SERVICE BULLETIN

93727-1 Piston (Item 107) Length Change

SB10x-x-x Shock Blocker Models

BULLETIN: #4-11

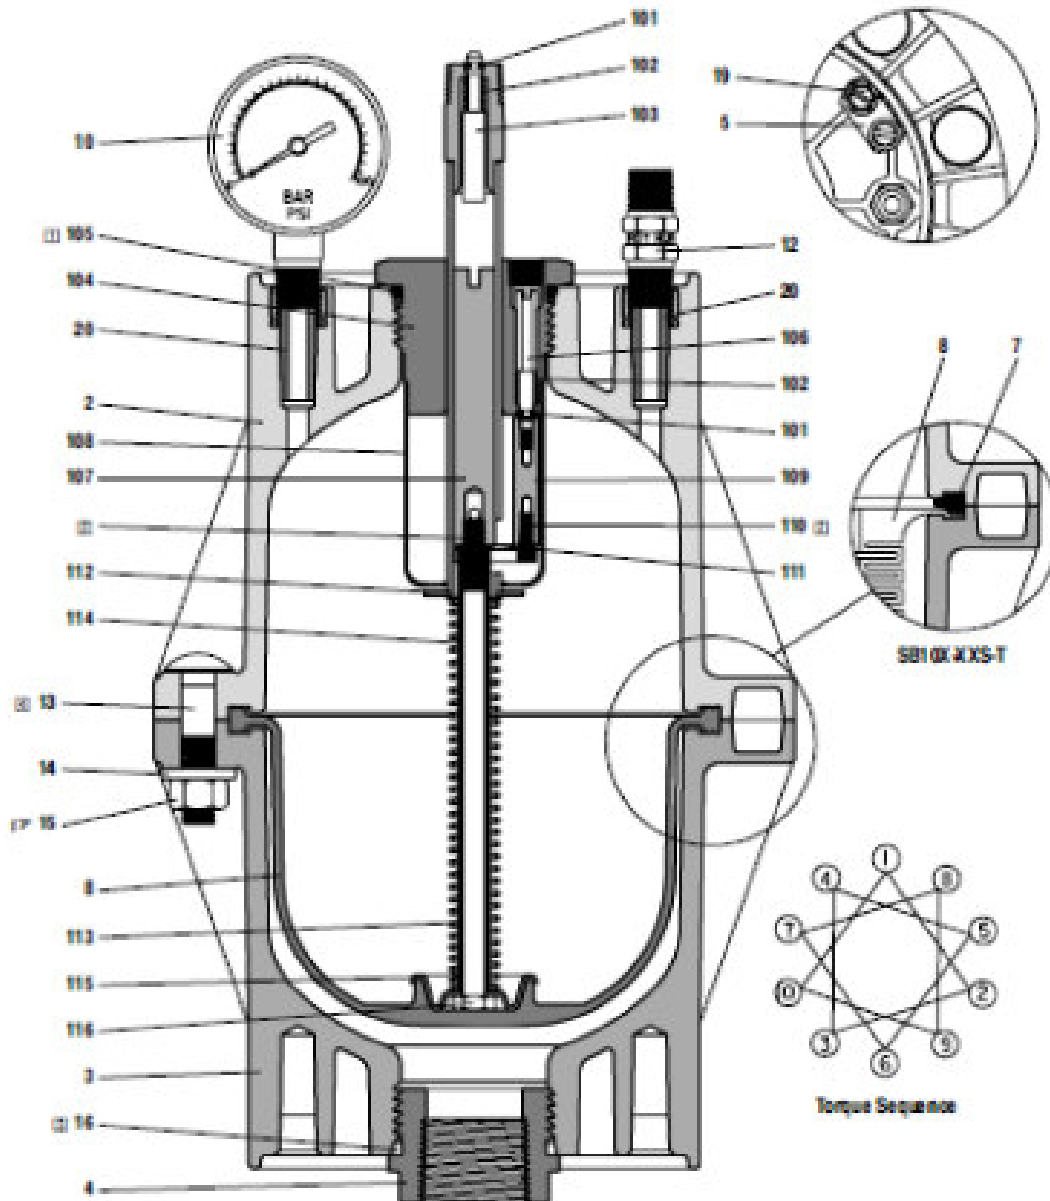
The length of 93727-1 changed from 3.250 to 3.468 to improve performance of the
66911-1 Air Tamer Assembly
